ZONING AMENDMENT STAFF REPORT**Date: November 1, 2007****NAME**

Harry Palmer

LOCATION4658 Airport Boulevard
(North side of Airport Boulevard, 200'+ West of South
University Boulevard)**CITY COUNCIL
DISTRICT**

REQUEST Rezoning from R-1 and B-2 to B-2

SITE PLAN

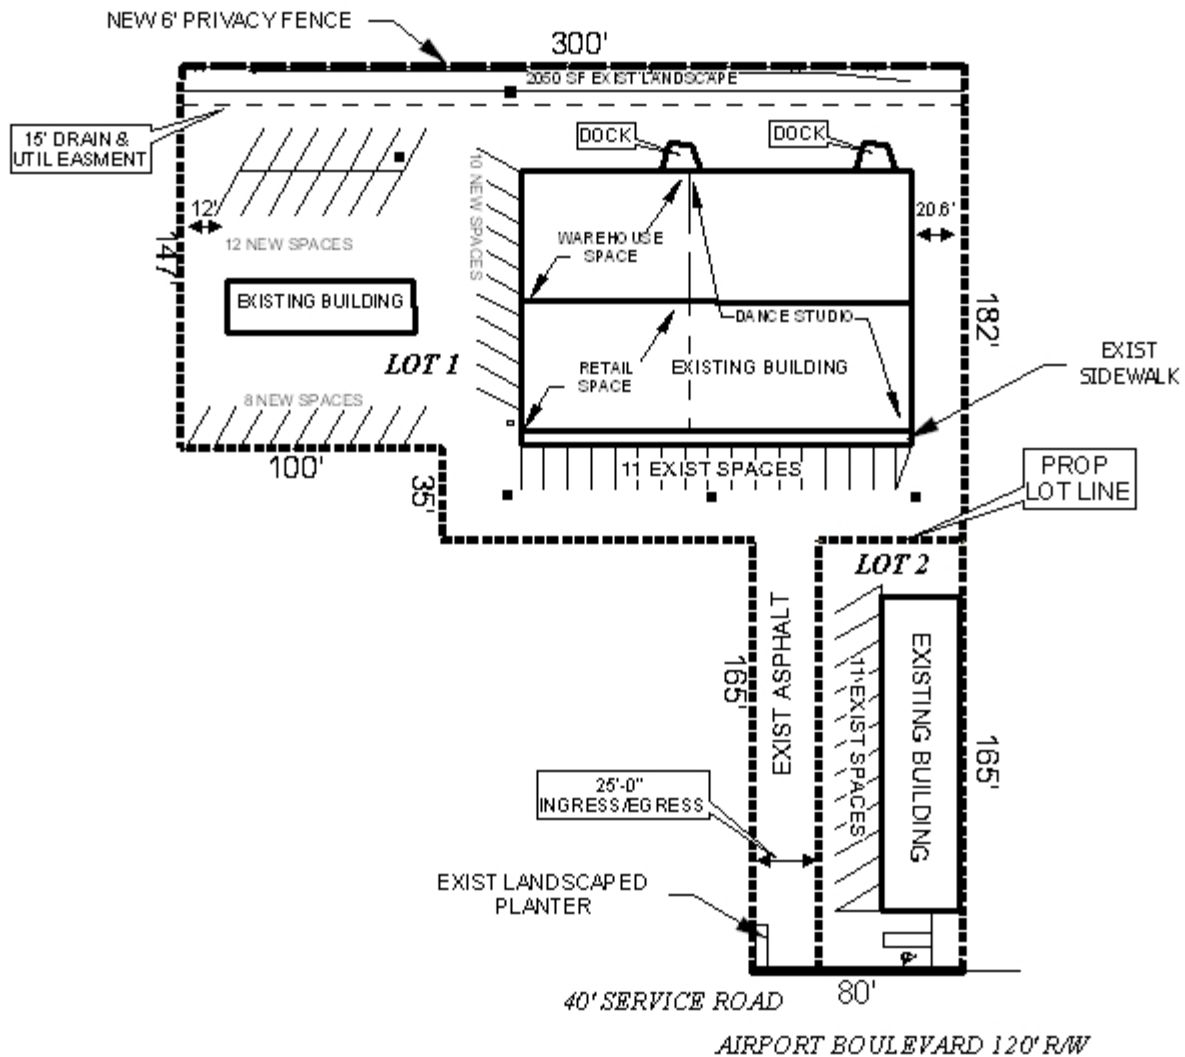
Driveway number, size, location, and design to be approved by Traffic Engineering and conform to AASHTO standards. The 60 degree angled parking shown does not meet the minimum requirements of an eighteen foot aisle width. Changes should be made to the aisle width or angle of parking to meet minimum requirements. Sign and mark all one-way aisles.

The site is currently developed, and the site plan provided with the application depicts additional parking that will be striped in order to comply with the parking quantity requirements for the existing uses. It should be noted that Traffic Engineering states that the proposed parking layout does not meet the dimensional requirements for angled parking.

- 1) Compliance with Traffic Engineering comments (*Driveway number, size, location, and design to be approved by Traffic Engineering and conform to AASHTO standards. The 60 degree angled parking shown does not meet the minimum requirements of an eighteen foot aisle width. Changes should be made to the aisle width or angle of parking to meet minimum requirements. Sign and mark all one-way aisles.*);
- 2) Provision of a 6-foot wooden privacy fence or buffer planting strip where the site abuts existing residential development, in compliance with section 64-4.D.1; and
- 3) Completion of the Subdivision process.
